IMPORTANT SAFETY RECALL

NHTSA Recall No. 24V-526

SN729

SUBJECT: Replacement Basket Bracket

Figure 1. Compatible Components - Original basket bracket and original basket bracket retaining pins
In production from 7/21/2014 through 7/30/2020

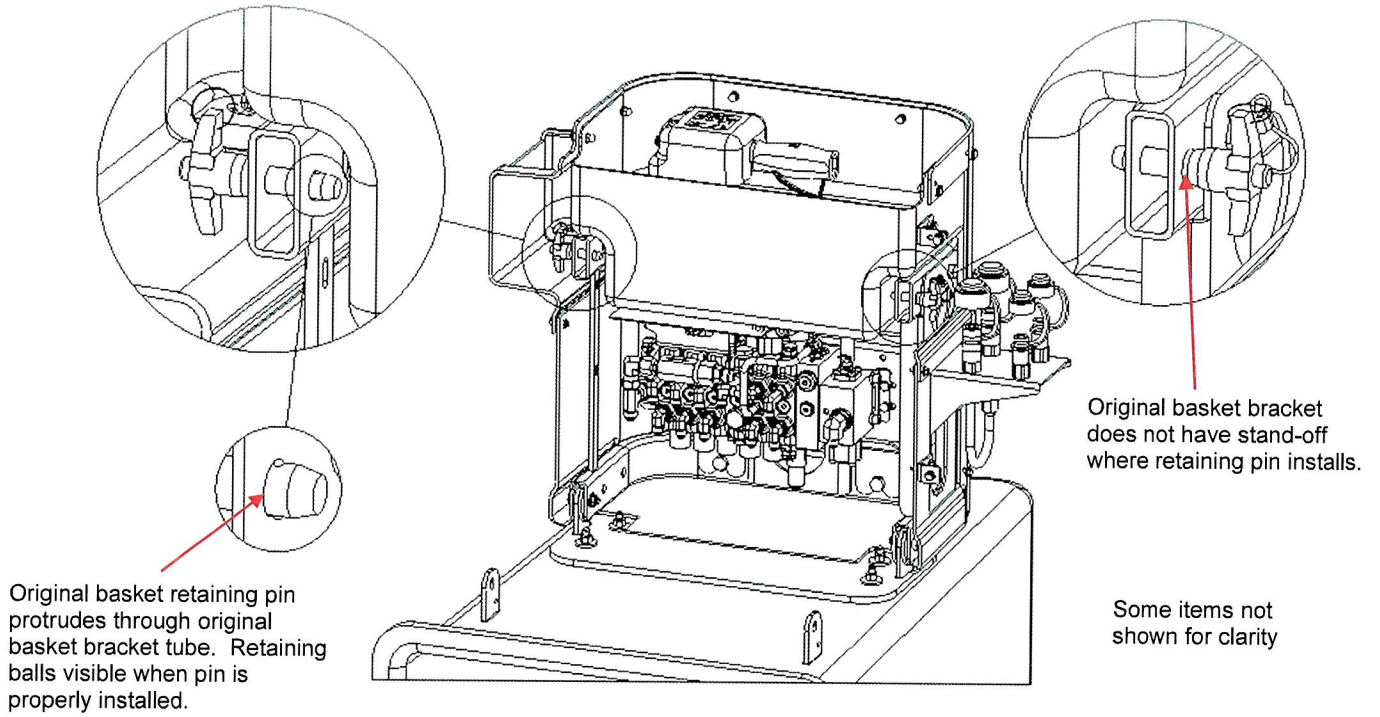
1. Immediately inform all users, operators, and supervisors of the contents of this bulletin.
2. Before the next use of the aerial device, inspect for compatibility of the basket bracket and the basket retaining pins using Figures 1 through 4 at the end of this bulletin as reference. Each basket retaining pin must extend through the basket bracket tube and the pin must have a method of retainment when the pin is fully installed such as retaining balls or secondary locking pins.

Figure 2. Incompatible Components - Replacement basket bracket and original basket bracket retaining pins

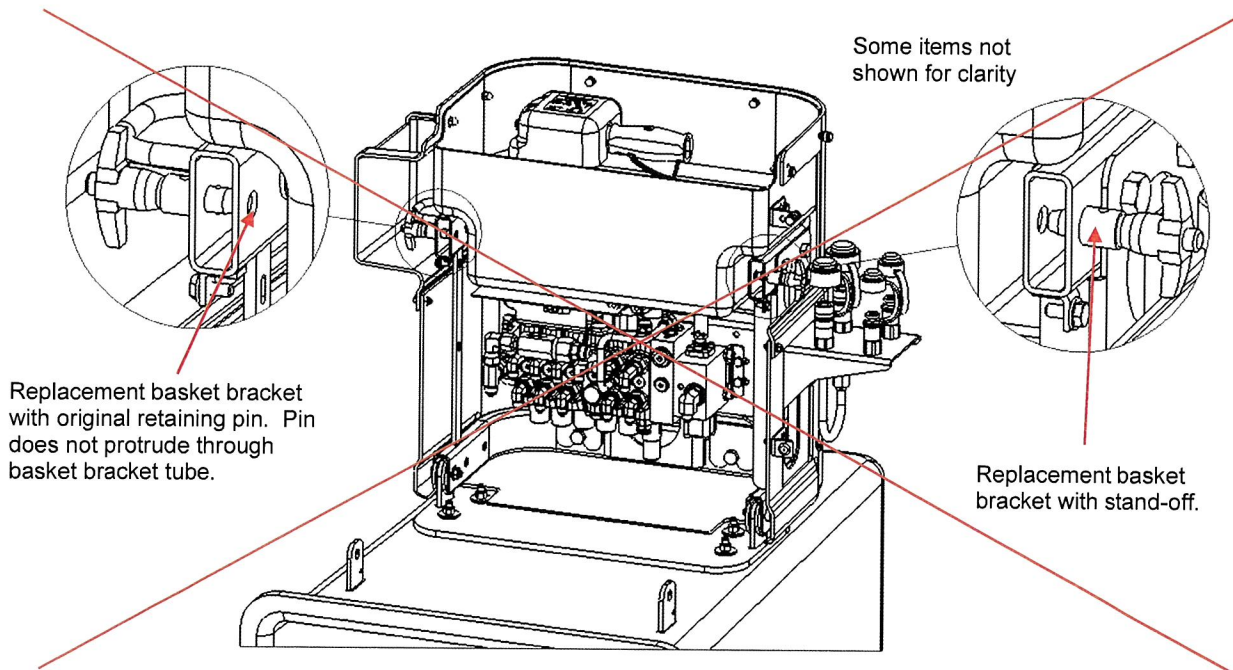
The new style replacement basket brackets as noted above may not be compatible with the original basket retaining pins on models manufactured prior to August 2020. **If both basket retaining pins disengage, the basket may tilt which can cause personal injury to the occupants of the basket.**

Terex will provide Field Service Kit Z1724, parts and labor, at no cost to the purchaser of the replacement brackets. The Field Service Kit Z1724 provides basket retaining pins and hardware to replace the original basket retaining pins. The remedy will take approximately one (1) hour to complete.
